JNU DOUGLAS HIGHWAY PM CONSTRUCTION STAGE I
PROJECT NO. SFHWY00293/958032

GRADING, DRAINAGE, PAVING, SIDEWALKS & CURB RAMPS

The undersigned hereby certifies that this duplicated document is an exact and true copy of the original.
Jessica Pickala

STATE	PROJECT DESIGNATION	YEAR	SHEET NO.	TOTAL SHEETS
ALASKA	SFHWY00293/0958032	2020	F5	F9

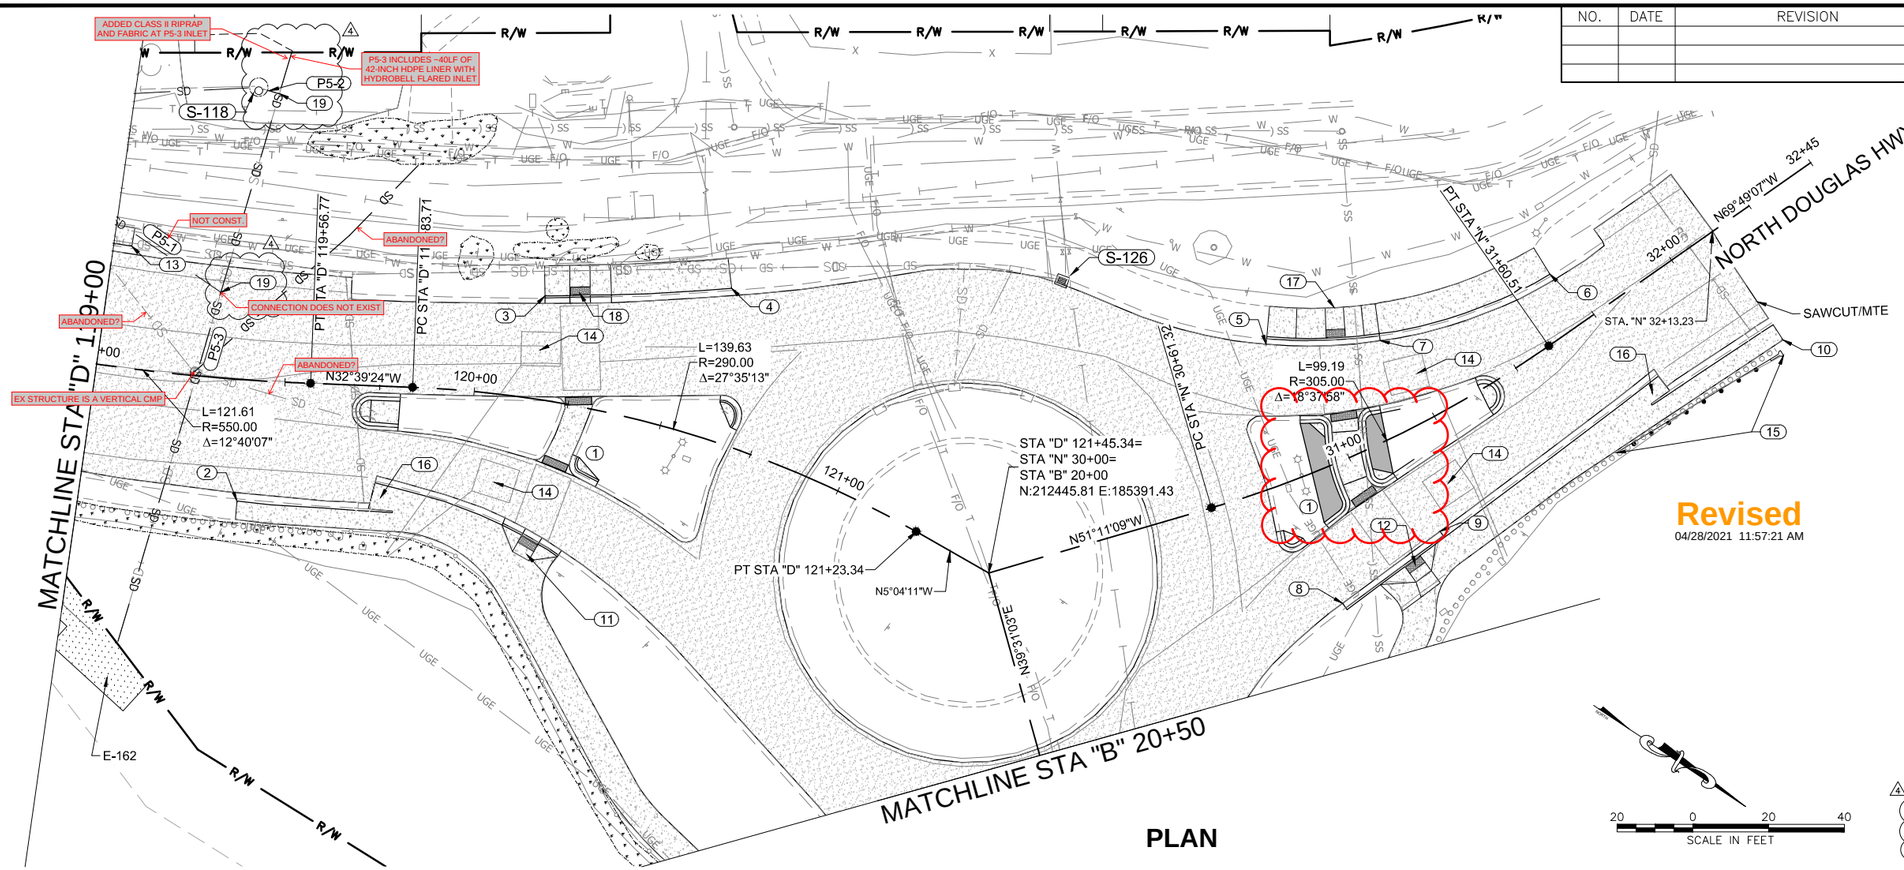
△4
19. INSTALL SADDLE BRANCH (SEE SHEET E3). CONTRACTOR SHALL FIELD VERIFY LOCATION OF EXISTING CONNECTION.
NO EXISTING CONNECTION.
NEW CONNECTION NOT CONSTRUCTED

STATE	PROJECT DESIGNATION	YEAR	SHEET NO.	TOTAL SHEETS
ALASKA	SFHWY00293/0958032	2020	F8	F9

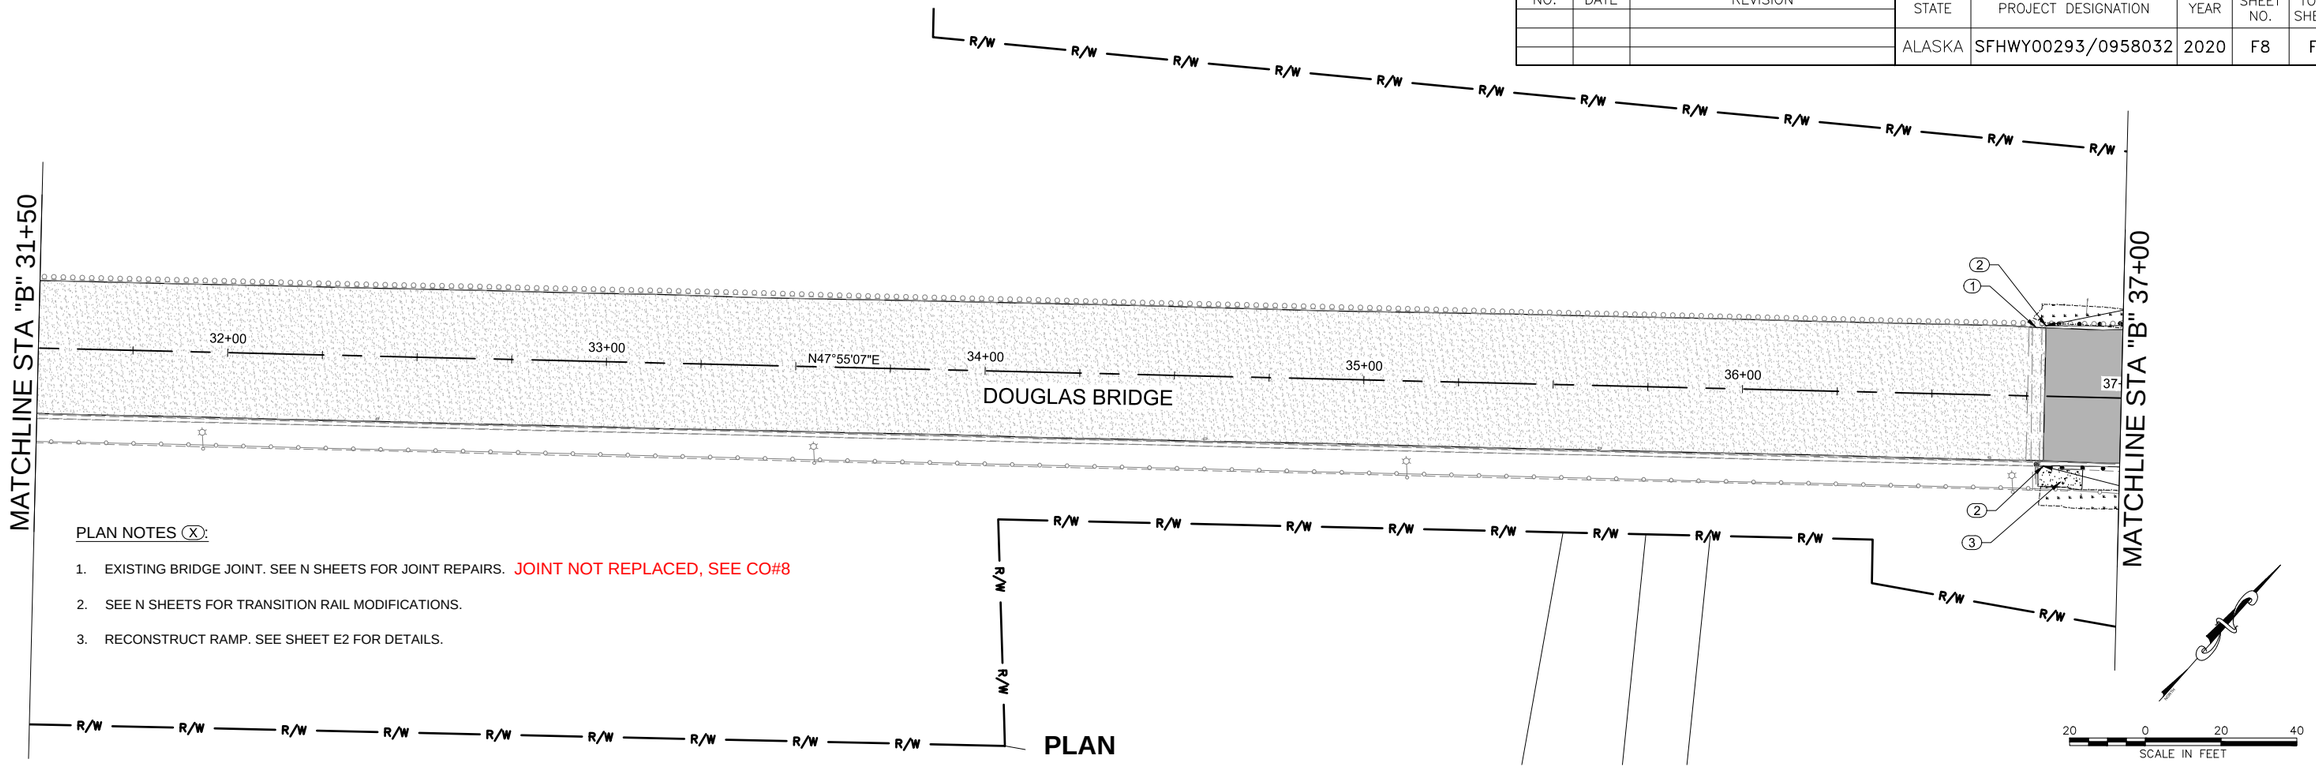
1. EXISTING BRIDGE JOINT. SEE N SHEETS FOR JOINT REPAIRS. JOINT NOT REPLACED, SEE CO#8
2. SEE N SHEETS FOR TRANSITION RAIL MODIFICATIONS.
3. RECONSTRUCT RAMP. SEE SHEET E2 FOR DETAILS.

STATE	PROJECT DESIGNATION	YEAR	SHEET NO.	TOTAL SHEETS
ALASKA	SFHWY00293/0958032	2020	F9	F9

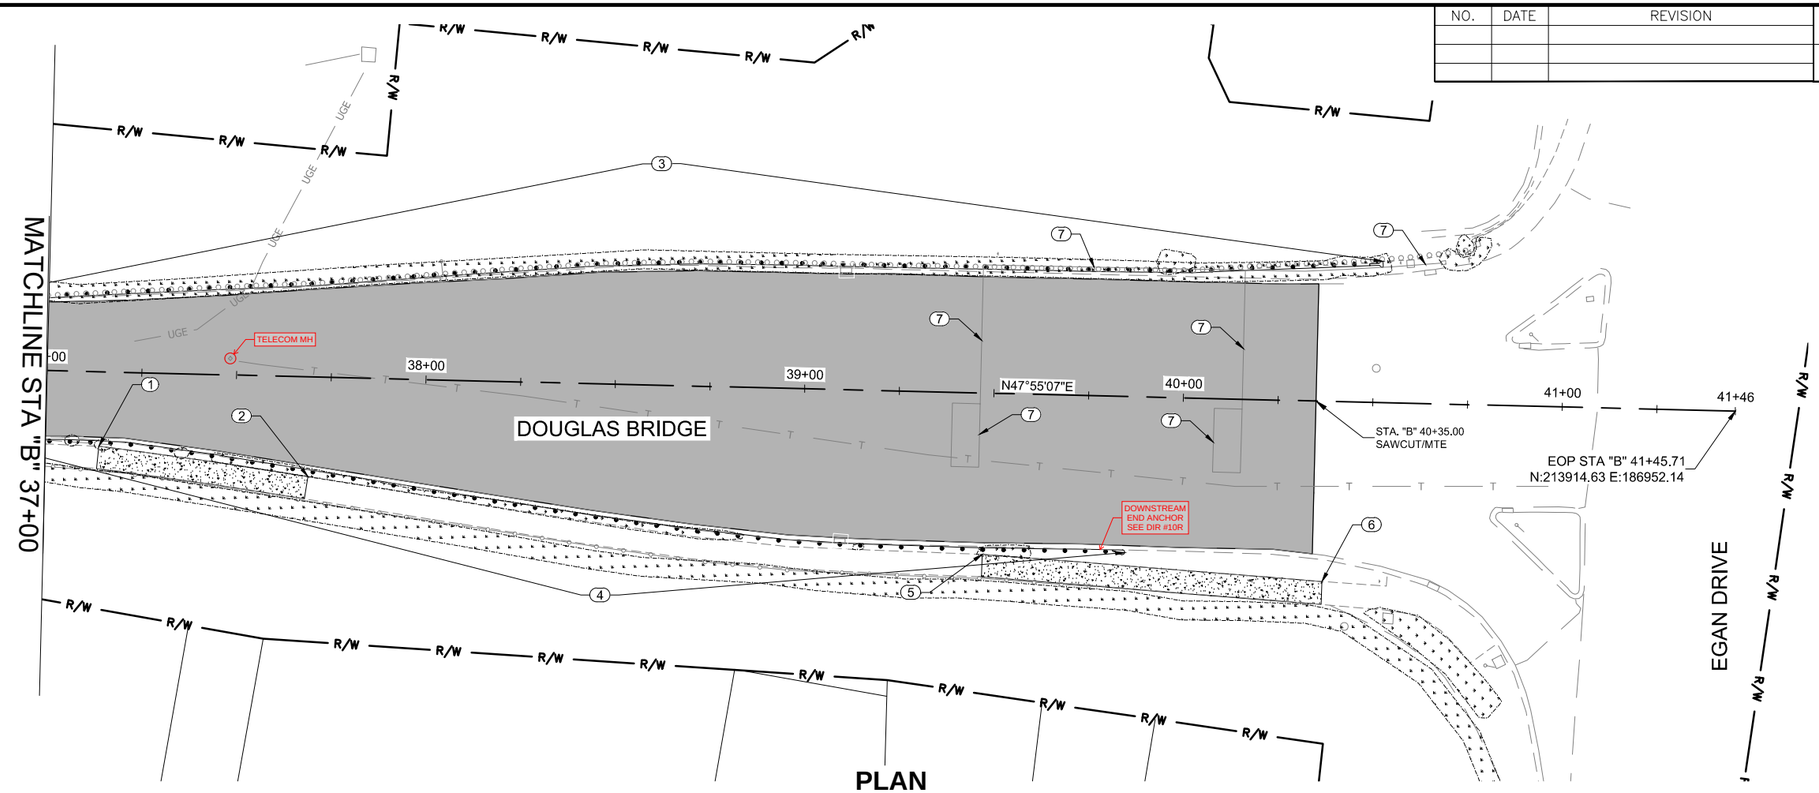
1. STA "B" 37+14 RT. BEGIN NEW CONCRETE SIDEWALK.
2. STA "B" 37+69 RT. END NEW CONCRETE SIDEWALK.
3. REPLACE EXISTING GUARDRAIL (SEE STD PLAN G-05.11S). STA "B" 36+80 TO 40+52 LT.
4. REPLACE EXISTING GUARDRAIL (SEE STD PLAN G-05.11S). STA "B" 36+80 TO 39+85 RT. INSTALL GUARDRAIL POST CORNER GUARD ON BACK OF GUARDRAIL POSTS PER DETAIL ON SHEET E2. (4)
5. STA "B" 39+48 RT. BEGIN NEW CONCRETE SIDEWALK.
6. STA "B" 40+38 RT. END NEW CONCRETE SIDEWALK.
7. APPROXIMATE LOCATION OF ABANDONED TRAFFIC LOOP DETECTOR SYSTEM. REMOVE AND DISPOSE OF EXISTING CONDUIT, WIRES, JUNCTION BOX, AND APPURTANCES. REMOVED

STATE	PROJECT DESIGNATION	YEAR	SHEET NO.	TOTAL SHEETS
ALASKA	0958032/SFHWY00293	2020	N4	N12

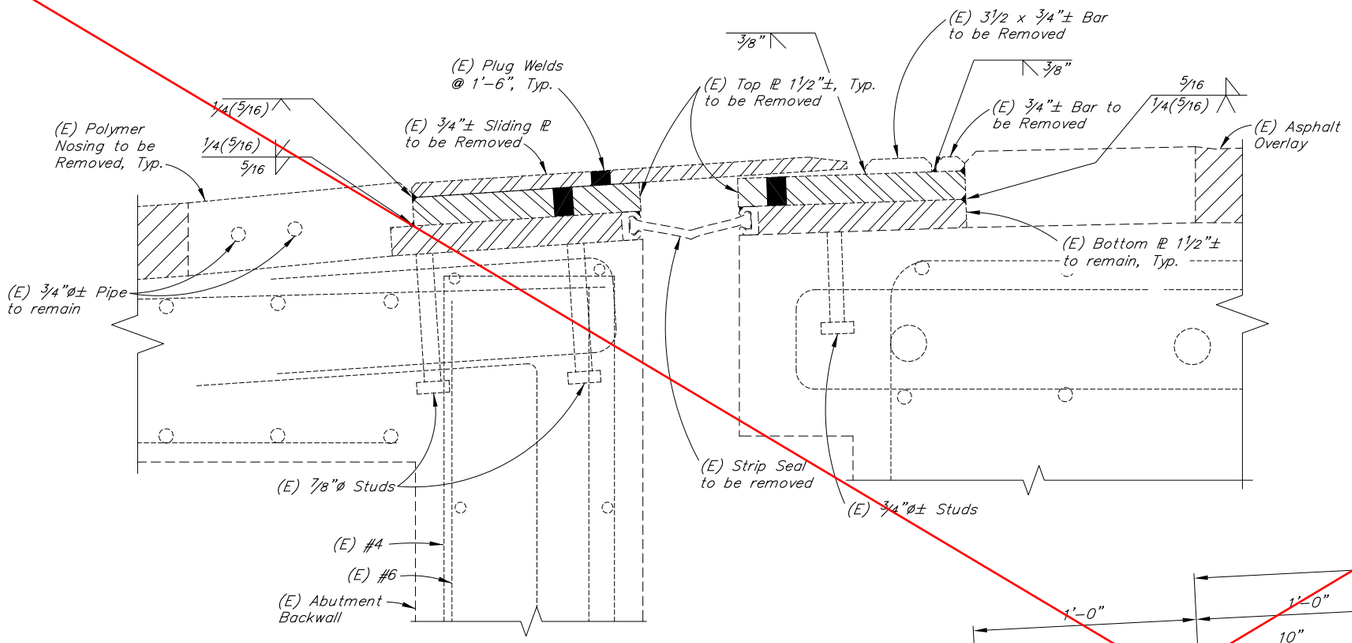
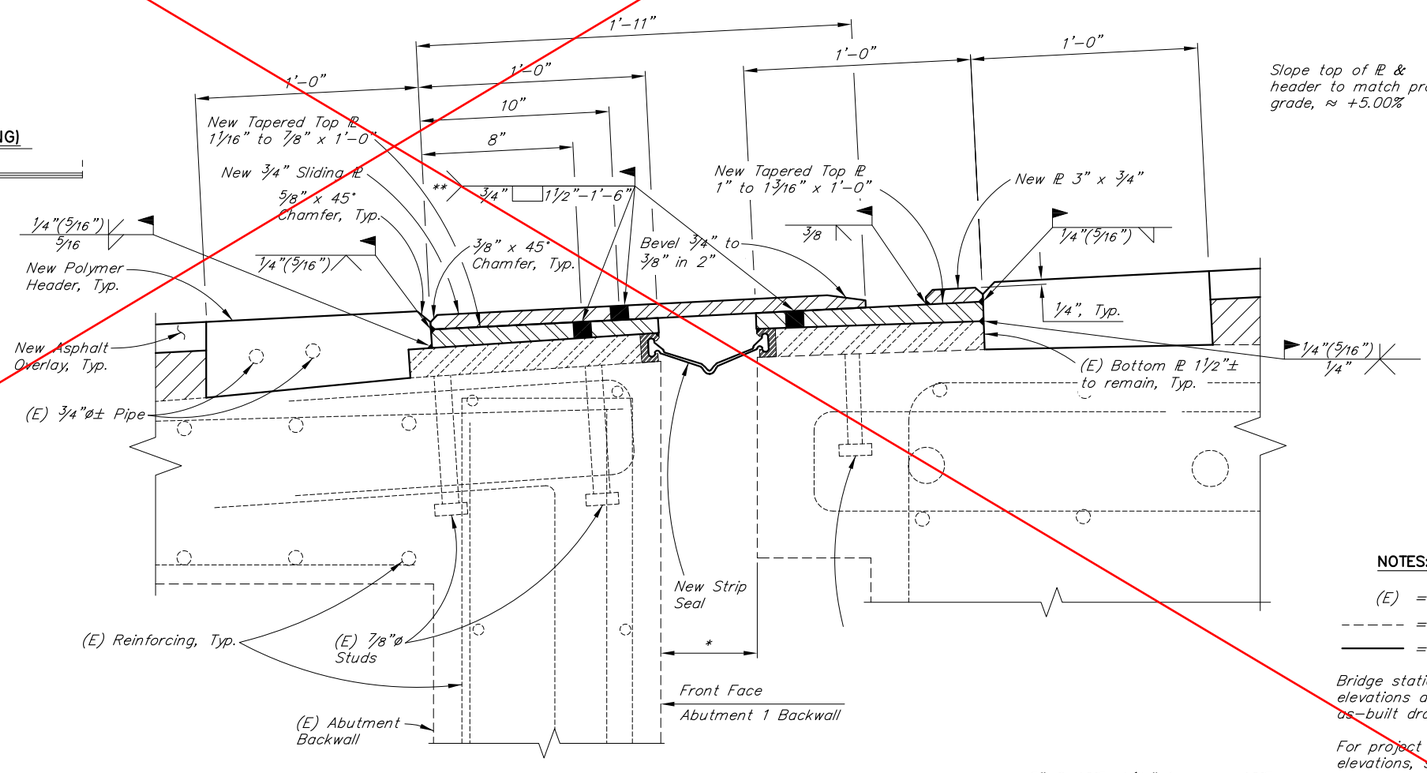
ELIMINATED, SEE CHANGE ORDER #8

EX. SWEEPER NOZZLE SYSTEM REMOVED
EX. STEEL PLATES AND STRIP SEAL REMAIN
POLYMER NOSING REPLACED WITH HMA, SP

STATE	PROJECT DESIGNATION	YEAR	SHEET NO.	TOTAL SHEETS
ALASKA	0958032/SFHWY00293	2020	N7	N12

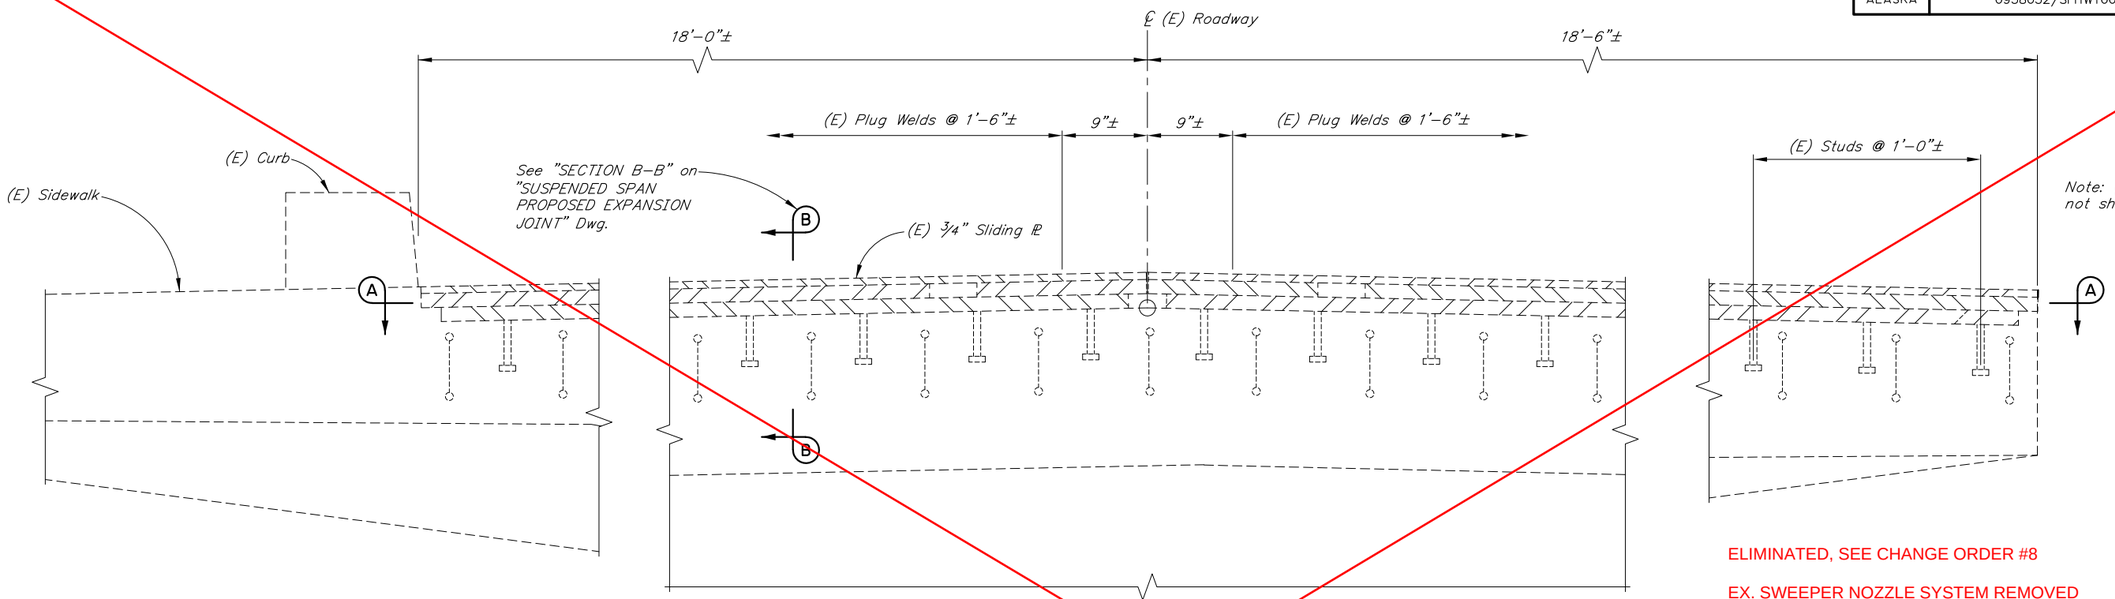
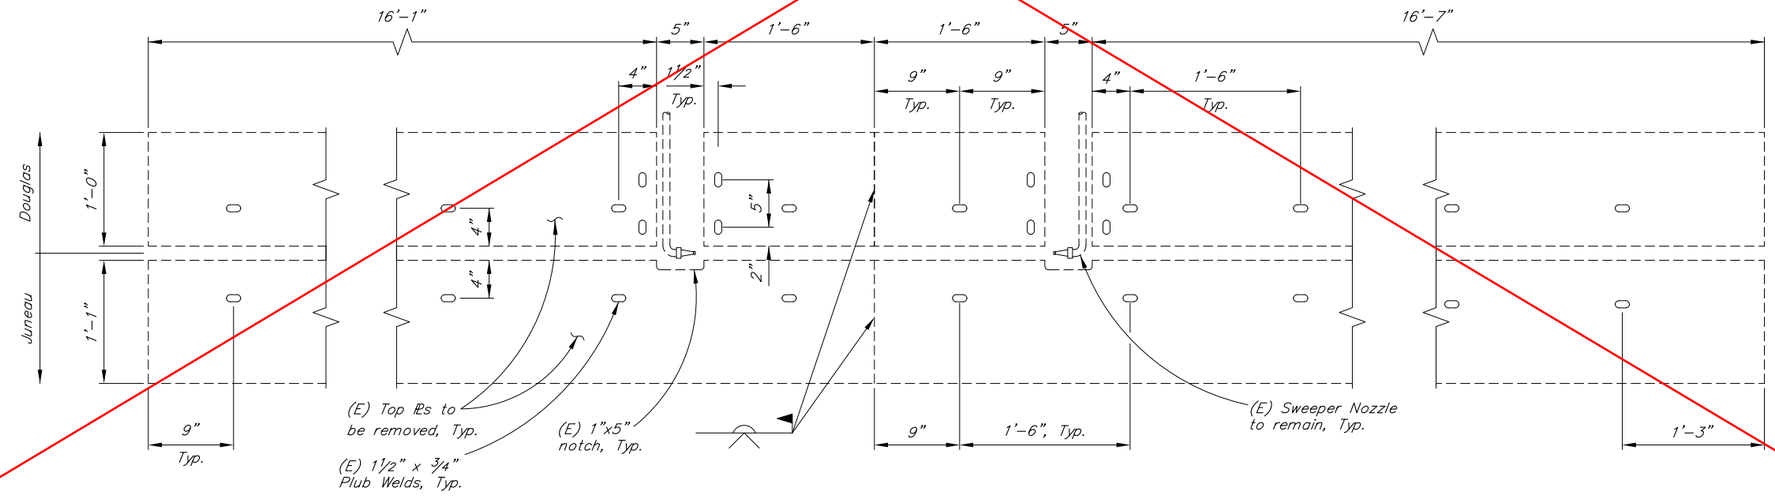
ELIMINATED, SEE CHANGE ORDER #8

EX. SWEEPER NOZZLE SYSTEM REMOVED
EX. STEEL PLATES AND STRIP SEAL REMAIN
POLYMER NOSING REPLACED WITH HMA, SP

P3-3 PLAN

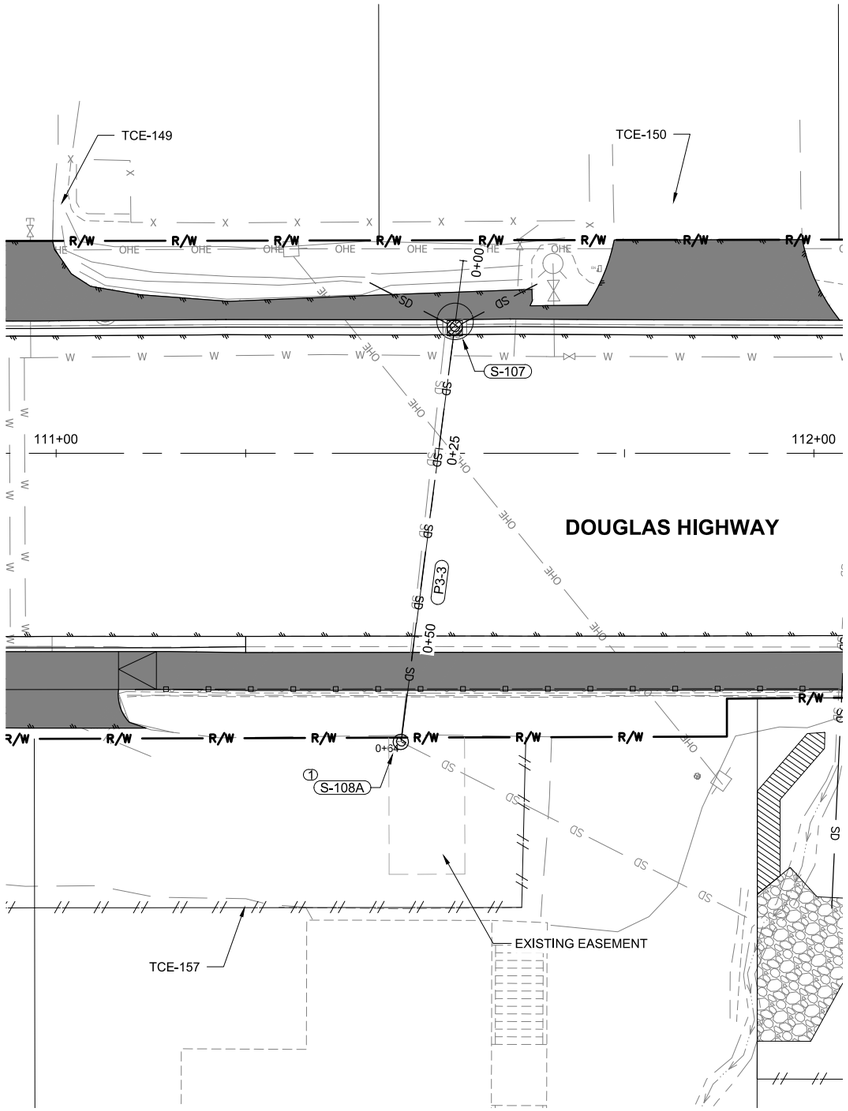
P3-3 CONSTRUCTED WITH CIPP
SEE SHEET F3 FOR ALIGNMENT INFO
